THIS IS **ONE** SECTION OF **TWENTY TWO,**
THAT FORMS PART OF A LARGER GROUP SUBMISSION
TO THE NEW ENGLAND REZ TRANSMISSION PROJECT
SSI-74175972

GROUP EIS SUBMISSION FOR THE NEW ENGLAND REZ TRANSMISSION PROJECT | SSI-74175972

Bushfire Risk

> Graph 1. Glenbawn Dam Historical Storage Volume, Inflow and Release
Source: https://waterinsights.waternsw.com.au/12801-hunter-regulated-river/storage#AMSRecent

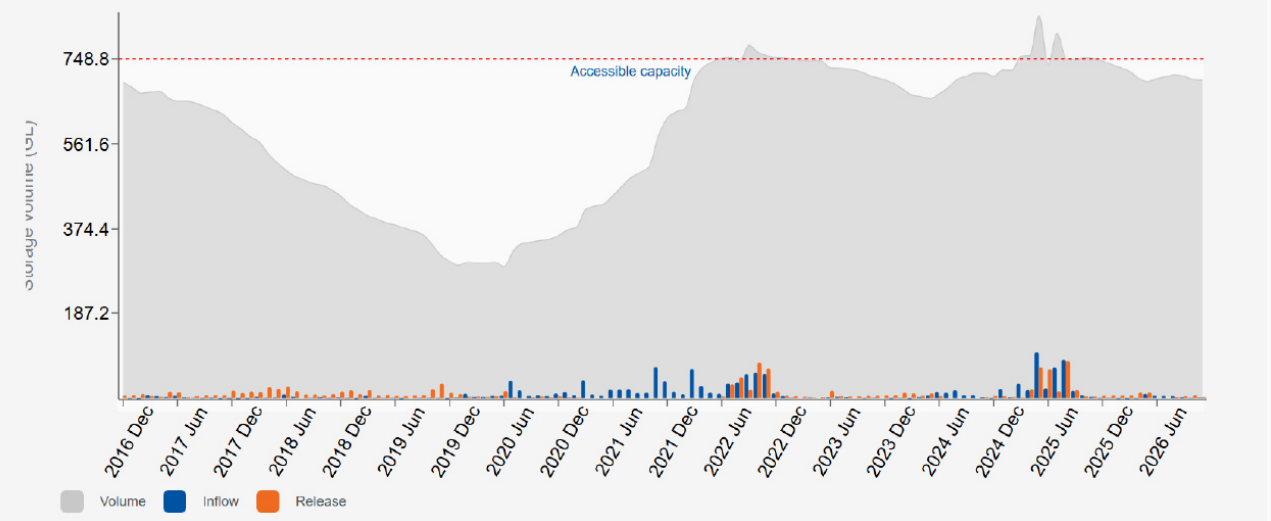
Using a full dam as the basis for these conclusions, without demonstrating that they remain valid at realistic drought levels, is a serious error of judgement by the EIS authors. A full dam cannot be assumed during a bushfire emergency. Prolonged dry conditions can leave the water surface substantially lower precisely when communities need effective aerial firefighting.

Low storage is a foreseeable operating condition that must be assessed. EnergyCo's own published information acknowledges that Glenbawn's storage varied between approximately 40% and 55% during 2019–2021. An assessment intended to protect firefighting operations must demonstrate safety under those conditions.

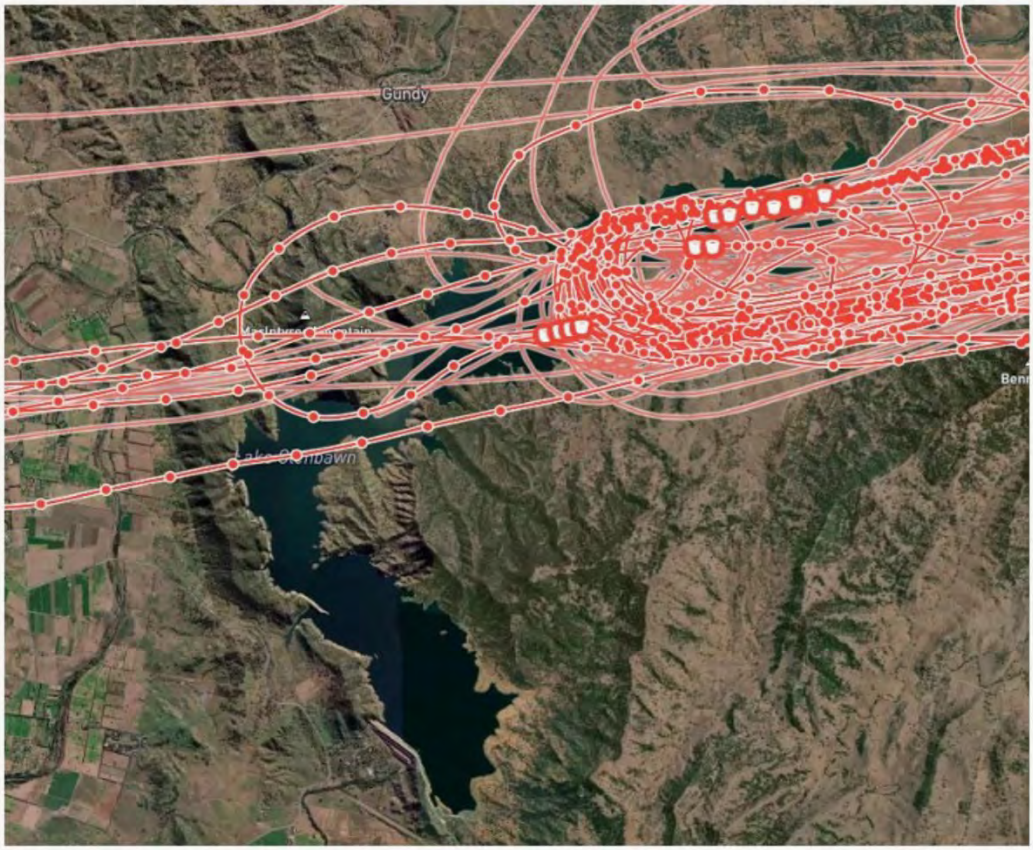
The consequences of this assumption are particularly serious in the assessment of operations at the eastern end of the lake. One worked approach in the technical note places the aircraft at approximately 385 metres AHD when crossing the transmission alignment, above a tower reaching 354.1 metres AHD. That provides approximately 31 metres of vertical separation, close to the assessment's adopted minimum of 30.5 metres.

At the assumed full-dam level, this approach provides approximately 871 metres of water-scooping distance. The report identifies an observed average scooping distance of approximately 700 metres for these eastern operations. These calculations depend on the assumed water elevation and the geometry of the approach.

If an aircraft follows the same approach angle towards the same touchdown location on a lower water surface, its calculated approach path also falls. This reduces clearance over the transmission infrastructure and could bring the aircraft dangerously close to the towers and wires, below the minimum separation adopted in the assessment.

If the aircraft instead maintains its clearance above the transmission infrastructure, it must descend farther before reaching the lower water surface. This moves the touchdown point farther along the approach and can consume the distance available for scooping. Falling storage also changes the shoreline, water depth and usable scooping area, requiring the entire operation to be reassessed.

The EIS must establish how safe approach, scooping and departure operations remain possible as the dam falls. The published full-dam calculations do not answer that question. A successful calculation at 276 metres AHD cannot establish that the same operation remains safe when the water surface is 16 or 27.5 metres lower.

This omission undermines the assessment's safety conclusions. It leaves unresolved whether pilots can maintain adequate separation from the transmission infrastructure while retaining sufficient water and distance to complete a safe and effective scoop.

The technical note itself describes its analysis as preliminary and warns that it should "not be relied upon for any decisions relating to actual flight performance and safety". That qualification makes it particularly unacceptable to treat the assessment as sufficient assurance that aerial firefighting will remain unaffected.

1. Publish revised flight-path and water-scooping assessments across a realistic range of storage levels, including historically experienced drought levels, using verified water elevations and corresponding shorelines.

2. Recalculate aircraft clearance, touchdown locations, usable scooping distances, departure paths and turning requirements at those levels, including the performance of aircraft carrying firefighting water loads.

Attachment A - Flight tracks and scooping zones for a single aircraft (VH-AP8) for the period 1st to 9th December 2025. The 'bucket' symbol indicates each individual scoop throughout the day.

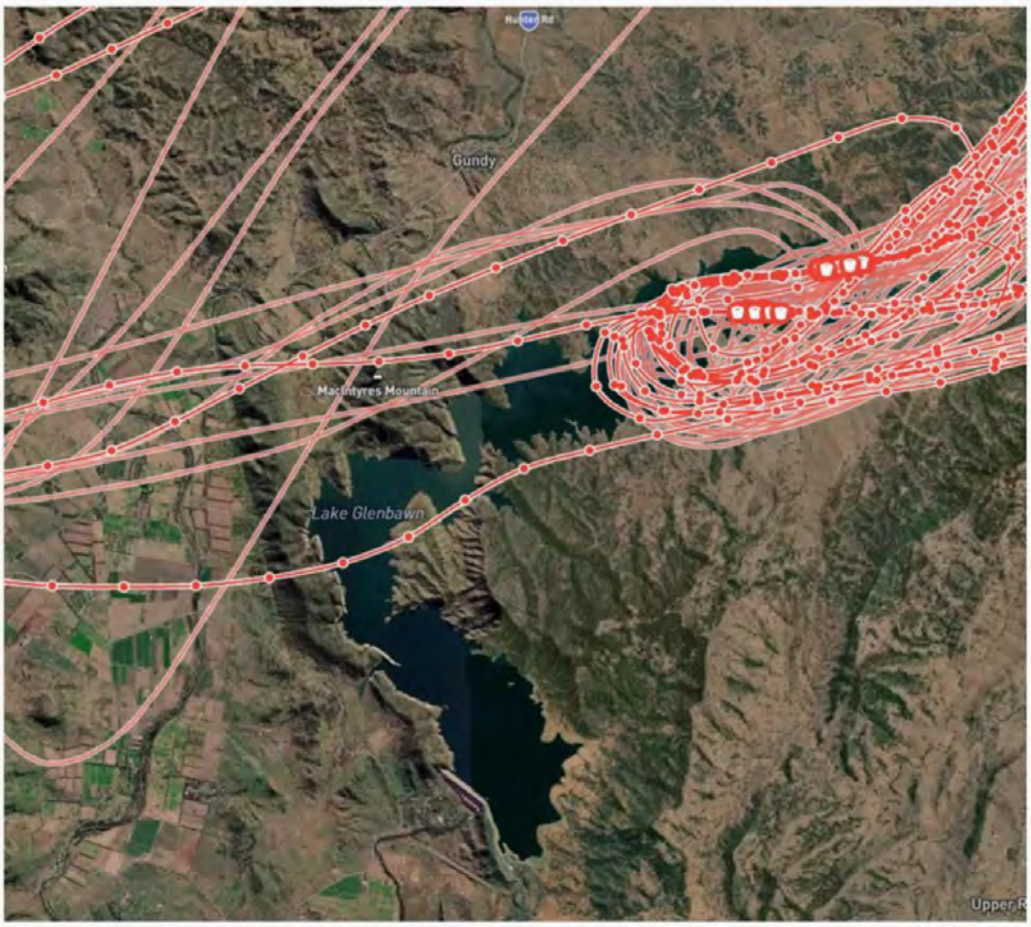
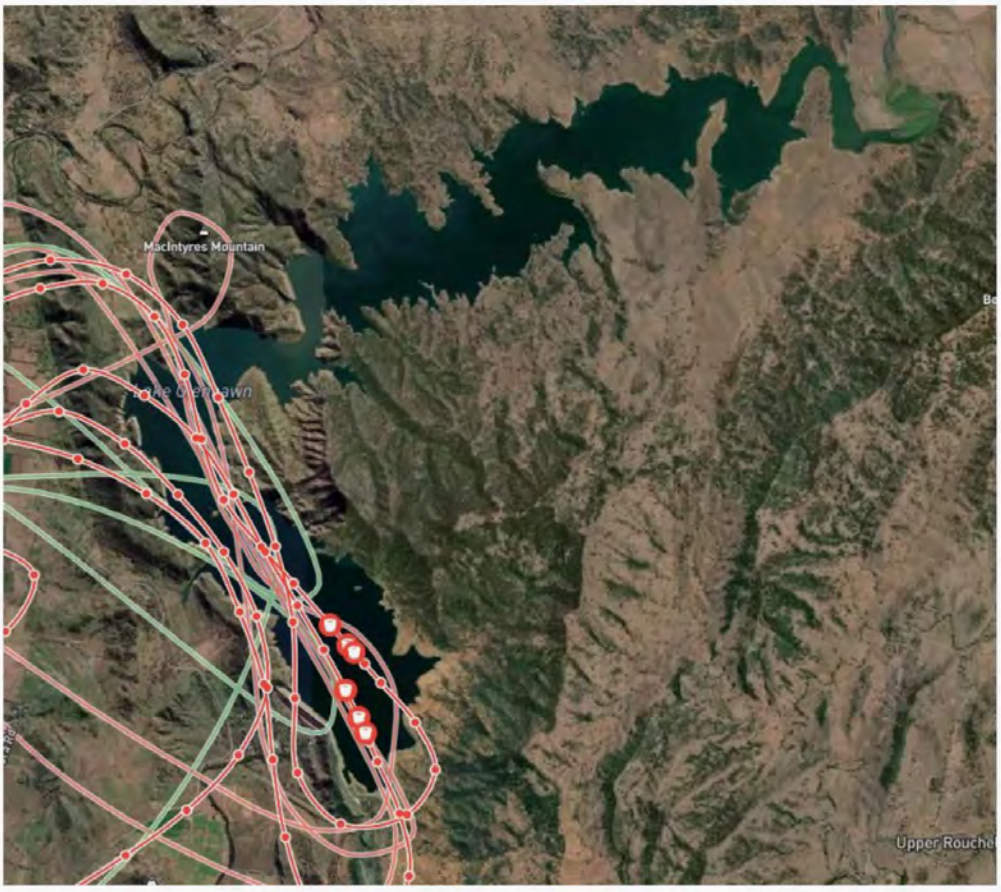
His recorded flights from 1–9 December 2025 demonstrate extensive use of Lake Glenbawn's eastern reaches for approaches, scooping and departures. This evidence shows why an assessment must account for the operating space pilots actually require as conditions change.

2019-20 fires and the proposed transmission route

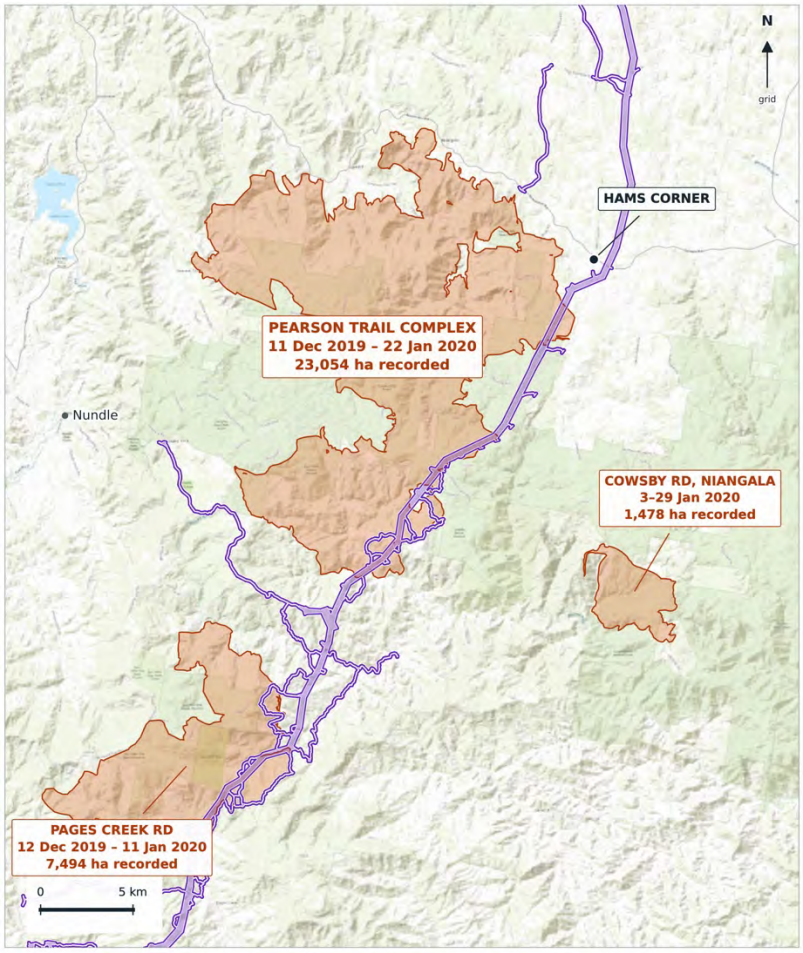
The project area includes access and work areas as well as the corridor, and the final easement is to be sited within it at detailed design. The recorded event windows of the Pearson Trail Complex and Pages Creek Road fires overlapped for about a month, and both final footprints intersect the project area. A reconstruction of fire progression is needed to establish when particular sections of the alignment would have been threatened.

The first-hand account of the Pearsons Trail fire in this submission describes what a six-week fire in the section TR12 itself identifies as highest risk looked like in practice. TR12 should be revised to include a complete fire history for the route, including how fires progressed along the alignment, and that history should be used to test how the line would operate through fires of that kind.
